STATE OF MAINE
DEPARTMENT OF TRANSPORTATION
16 STATE HOUSE STATION
AUGUSTA, MAINE 04333-0016

June 8, 2012
Subject: **Garland**
State PIN: 019334.00
Amendment No. 1

Make the following change to the Bid Documents:

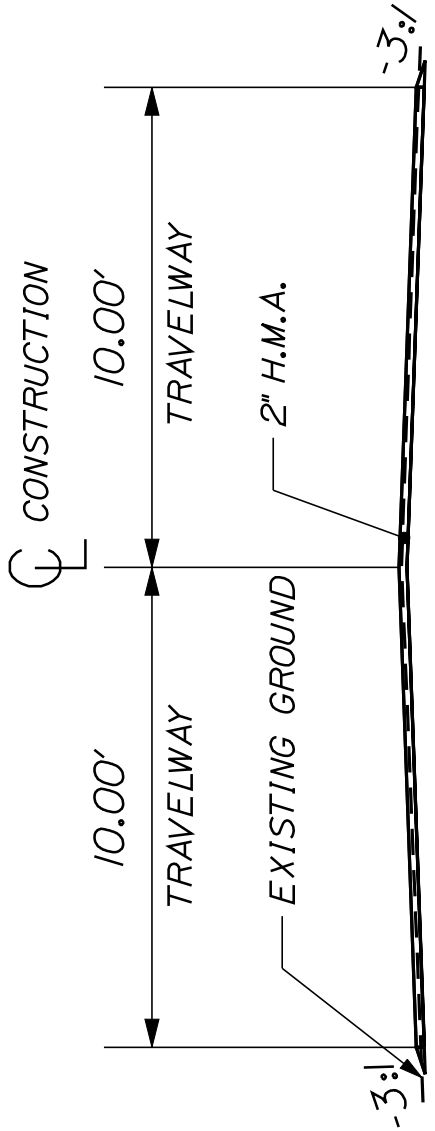
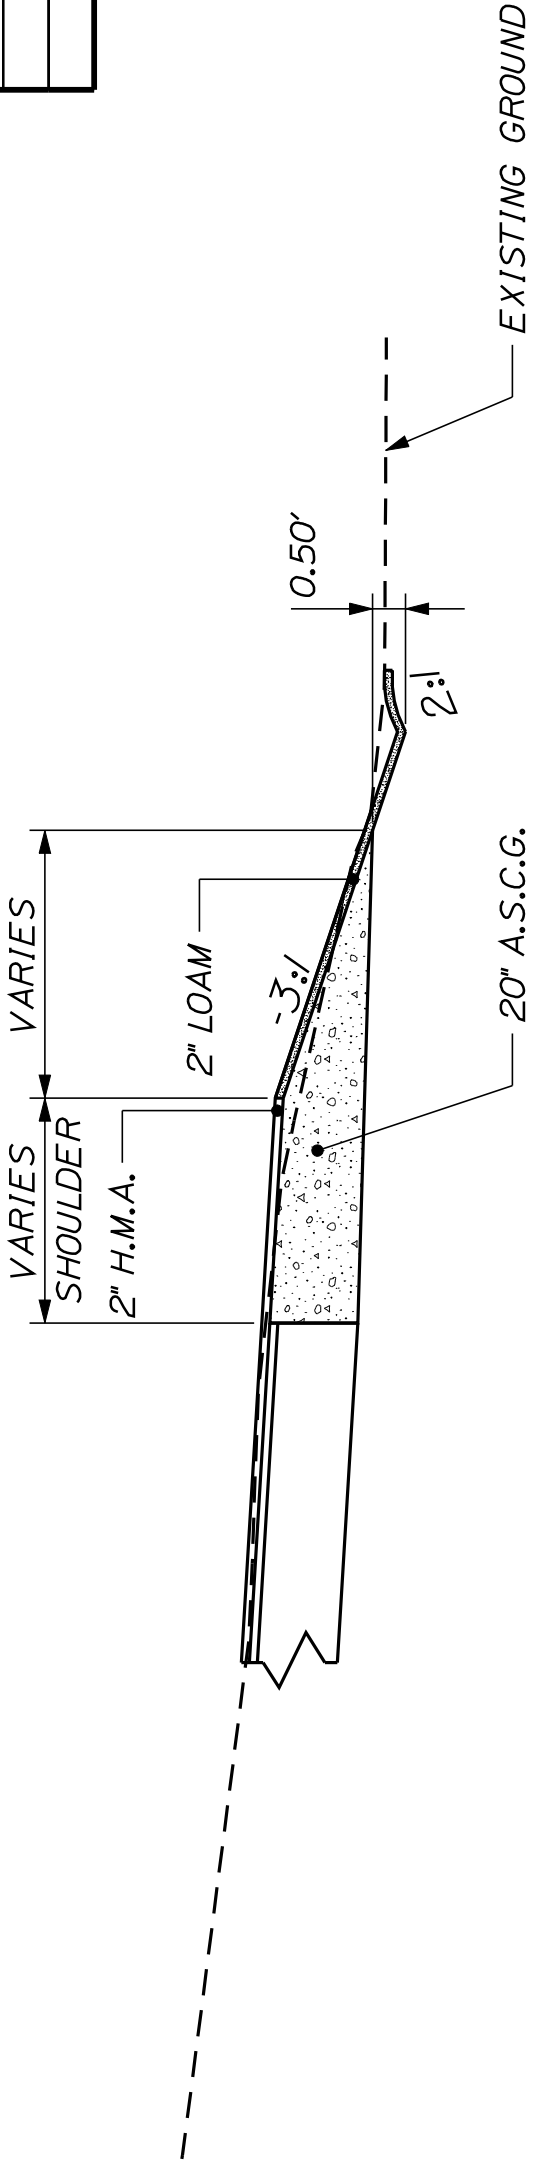
In the Plans **REMOVE** "SHEET NUMBER 2 OF 11" and "SHEET NUMBER 3 OF 11" (Typical Sections) and **REPLACE** with the attached new "SHEET NUMBER 2 OF 11" and "SHEET NUMBER 3 OF 11".
